SR 25 CO/West Bay Street From I-516 to the Bay Street Viaduct

NHS00-0002-00(923), P.I. No. 0002923
Chatham County, Georgia

Value Engineering Study Report

September 2009

P2
 Sheet 2 of 7
 Original Design

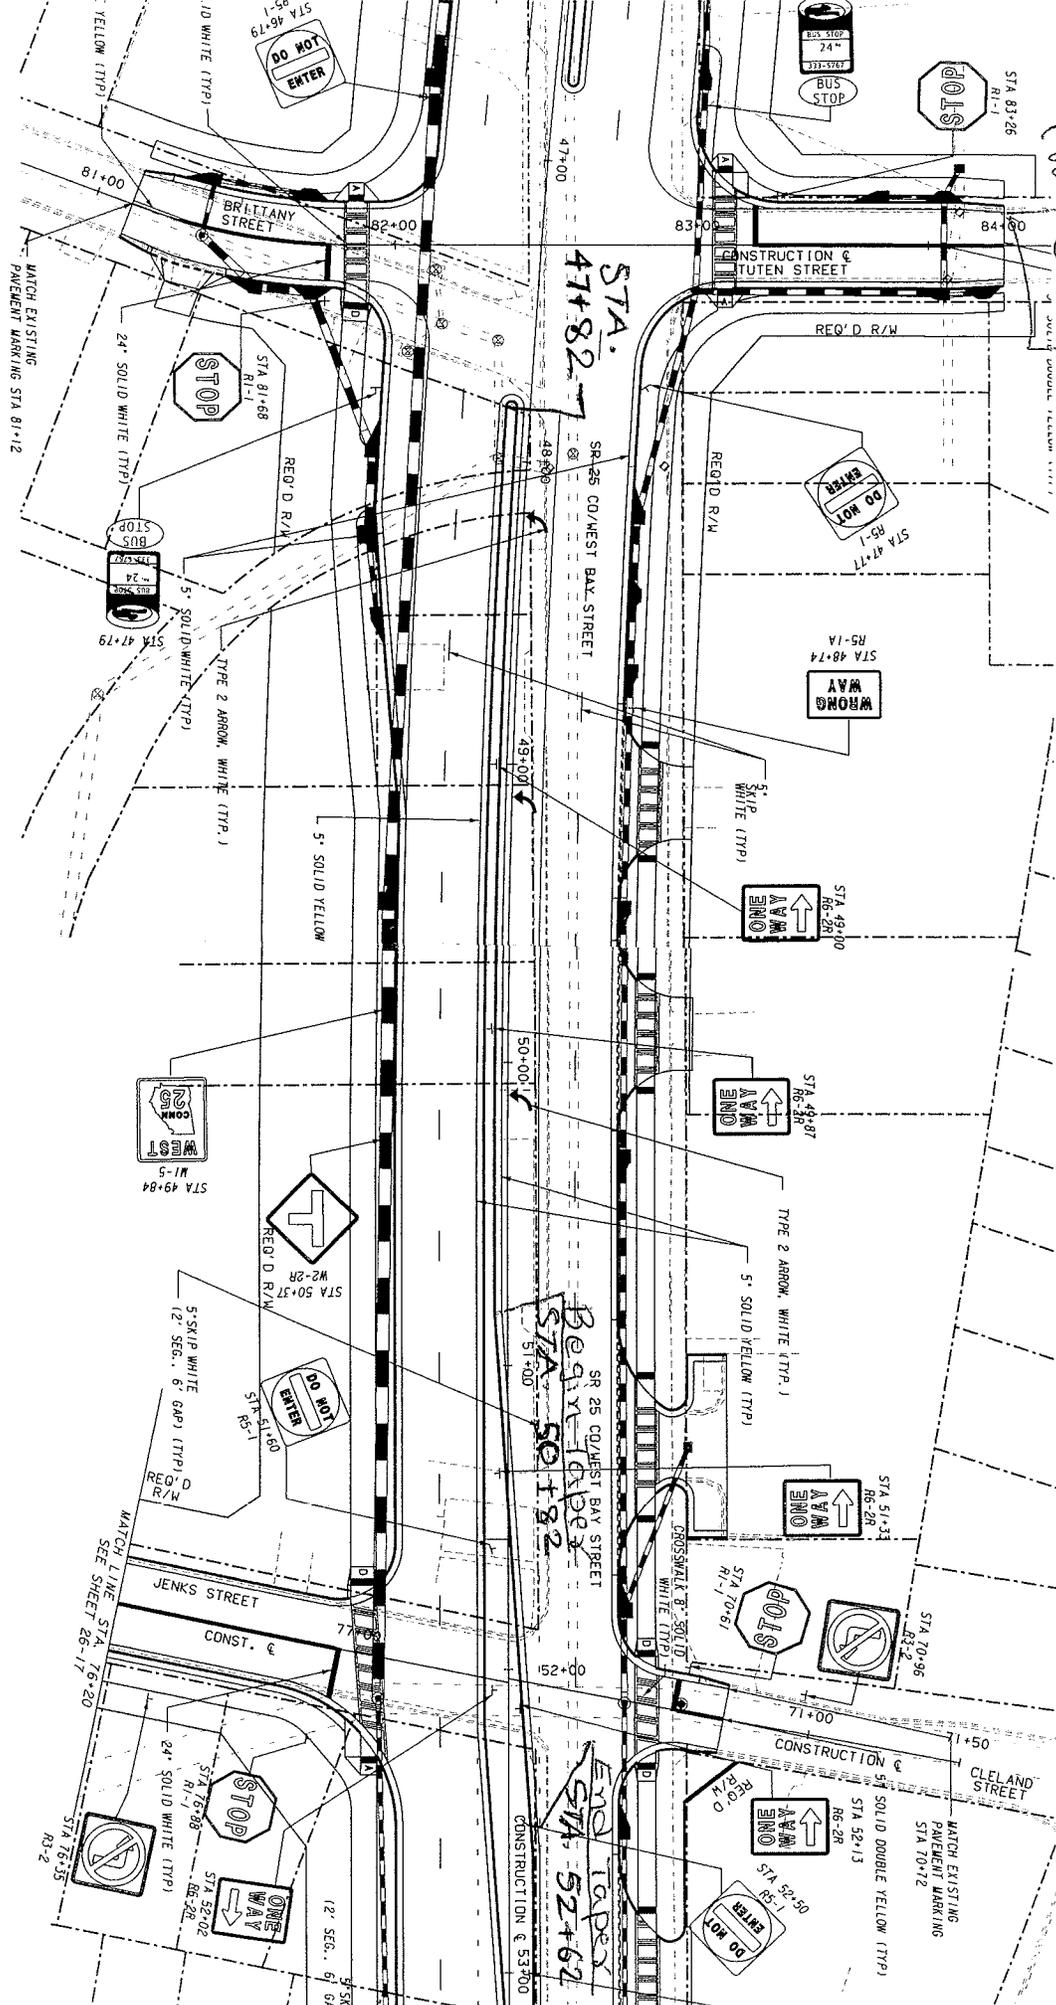
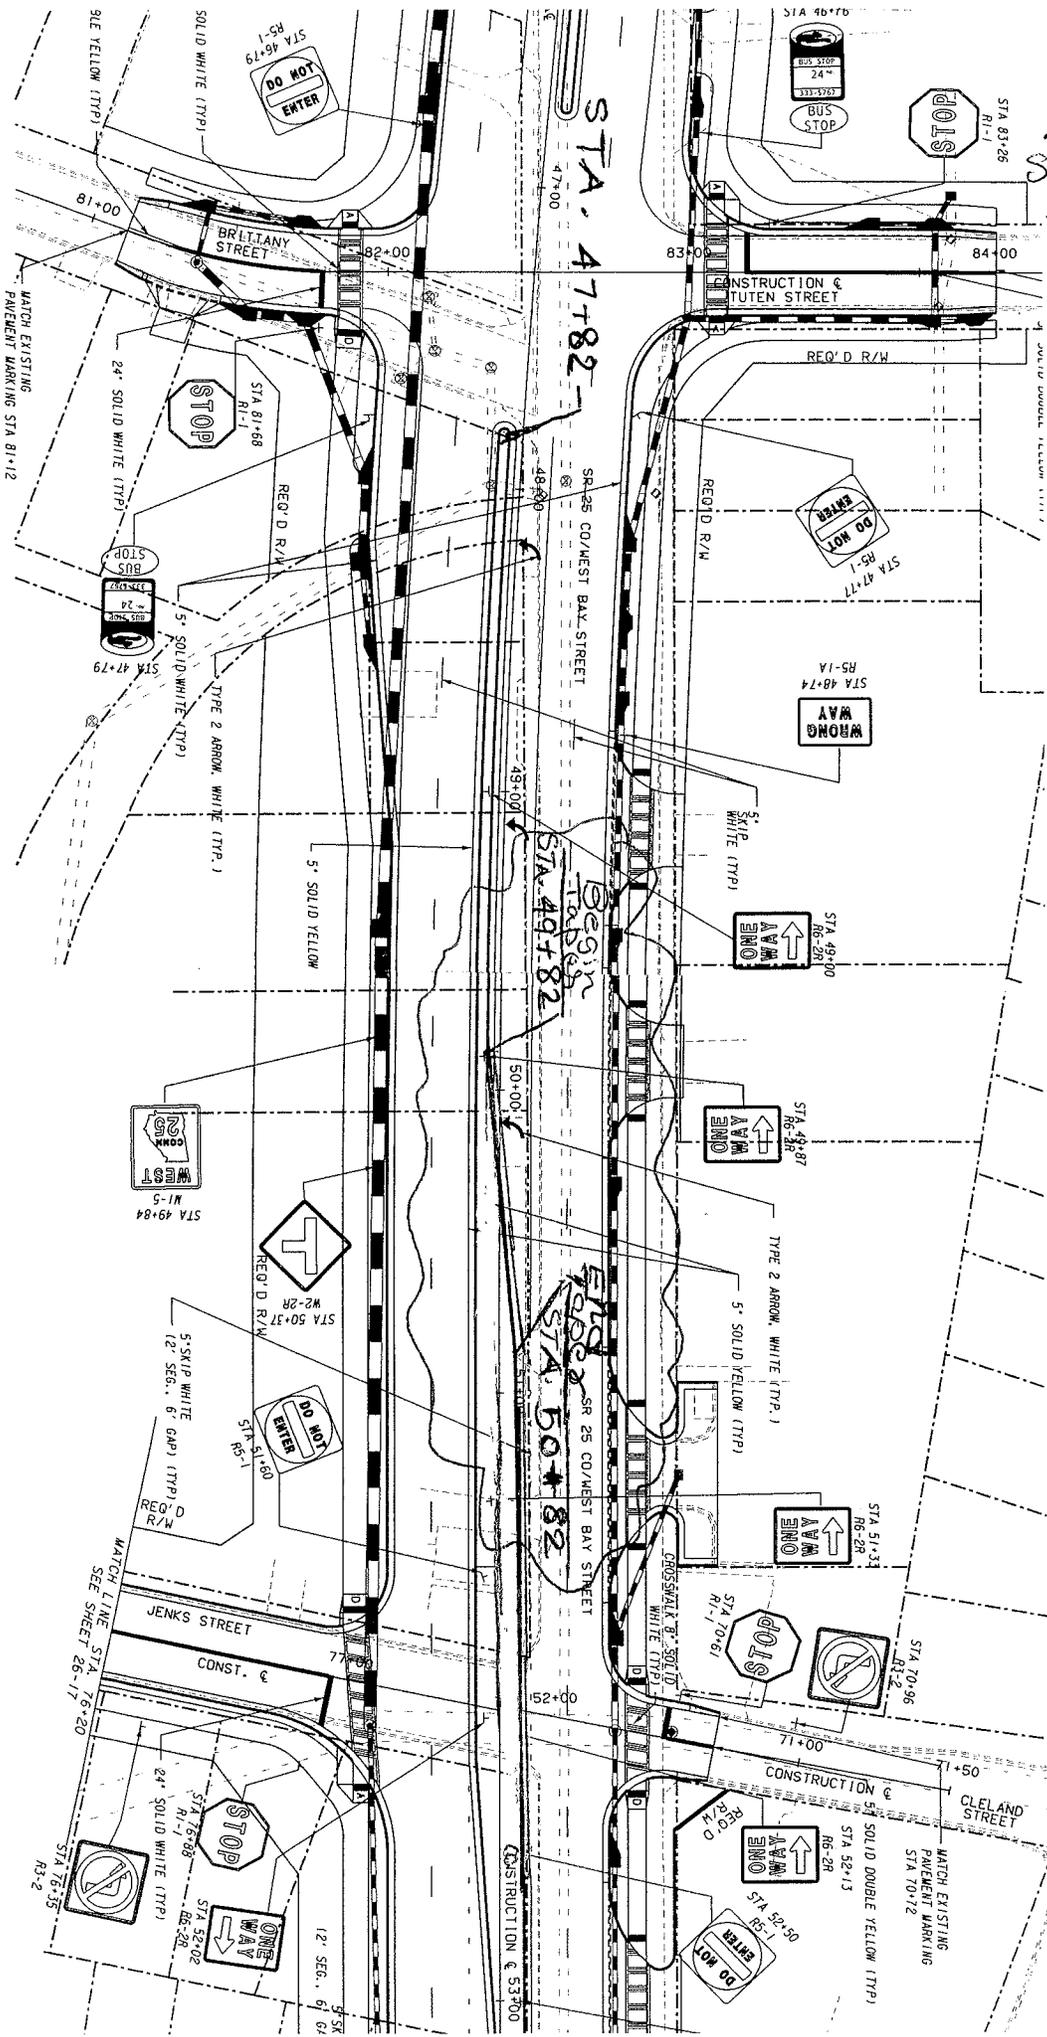
Per Georgia Construction Detail M-3, the minimum storage length required for an arterial with 35 mph is 200 ft and the minimum taper length required is 100 ft. The traffic count for the design year 2030 is not provided for vehicles turning left from Bay Street to Brittany Street. The assumption is that traffic turning left on Jenks Street from Bay Street will be divided equally between Brittany Street and Baker Street since the median of Jenks Street will be closed. This results in a maximum of 59 vehicles making the left turn in the peak hour.

Provide 200 ft of storage length and 100 ft of taper for the vehicles turning left onto Brittany Street. The storage length will be from Sta. 47+82 to Sta. 49+82. The taper length will be from Sta. 49+82 to Sta. 50+82.

CURB & CURB AND GUTTER

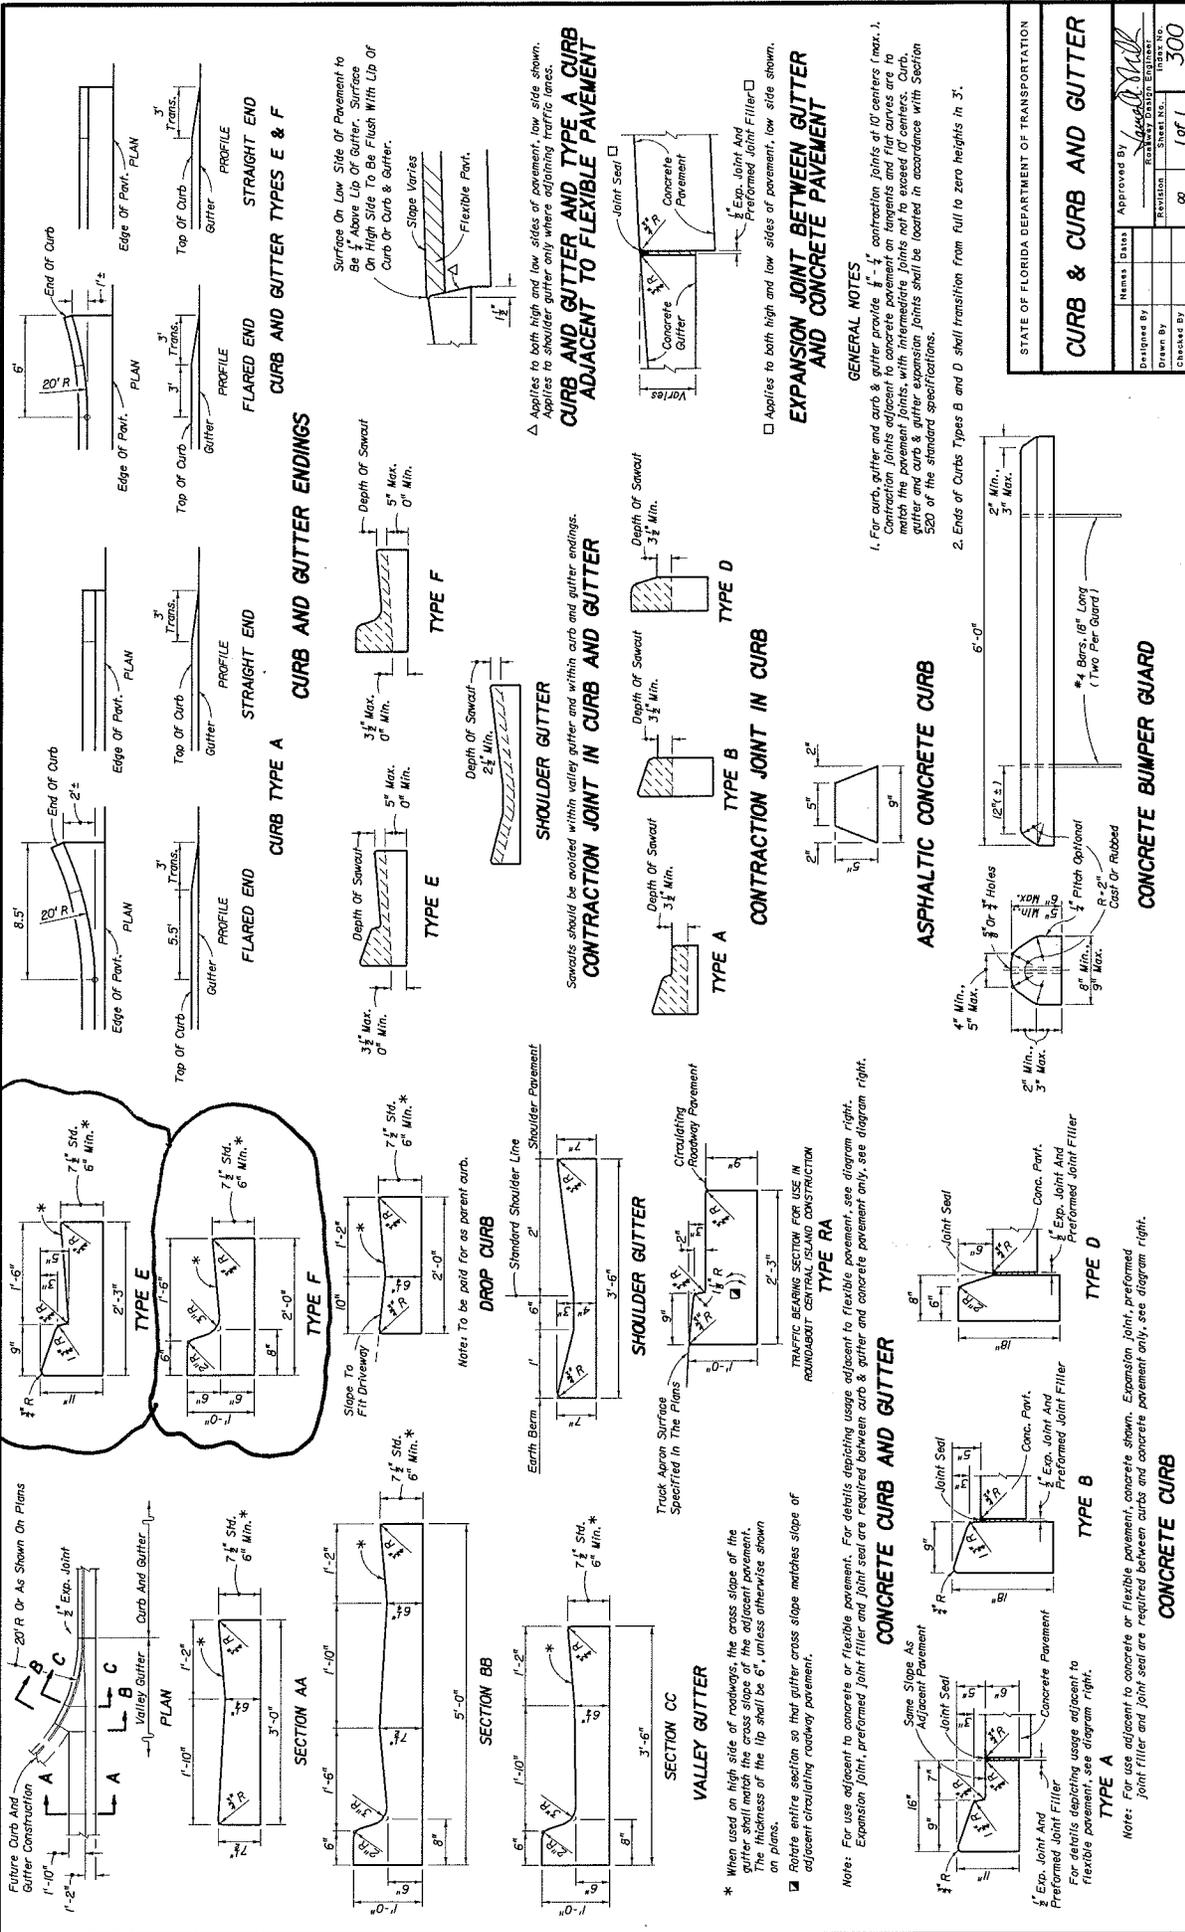
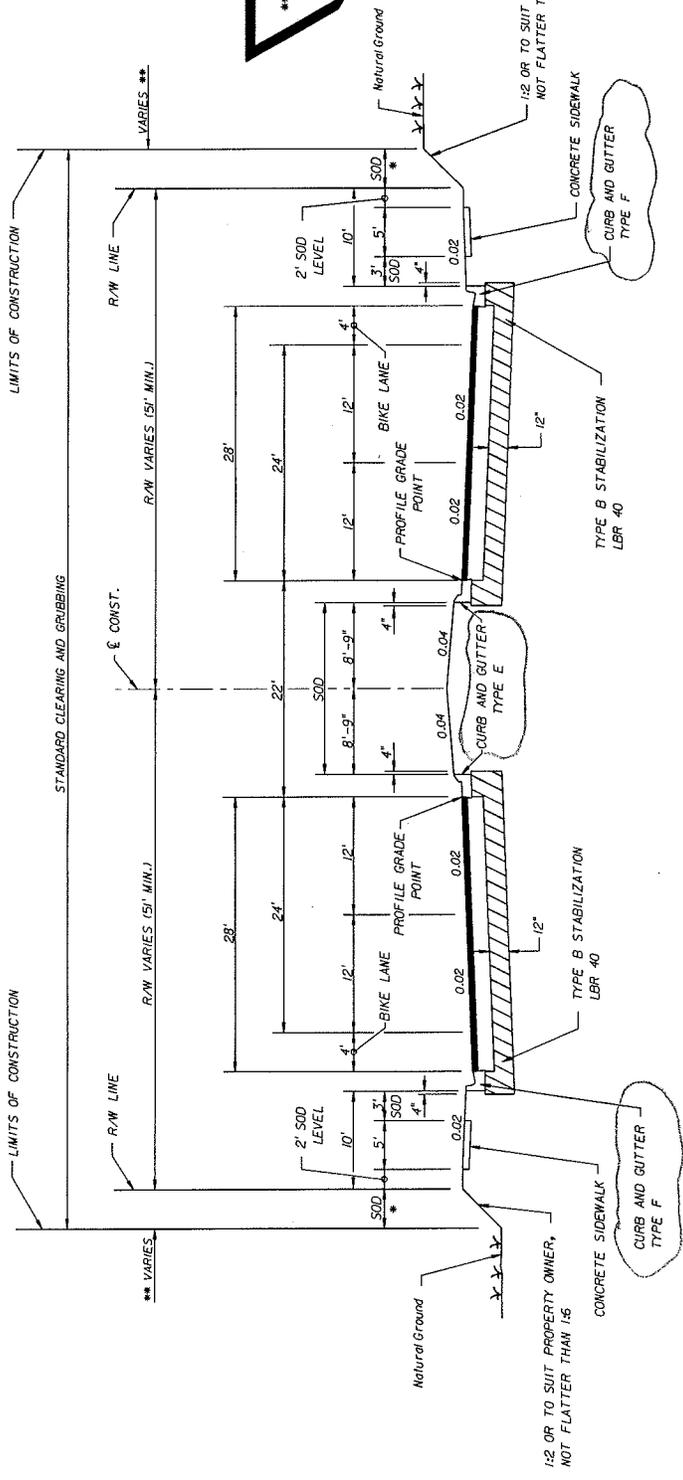
Note that the Florida DOT typically uses 1 ft 6 in gutter pans as shown on the attached sketches.
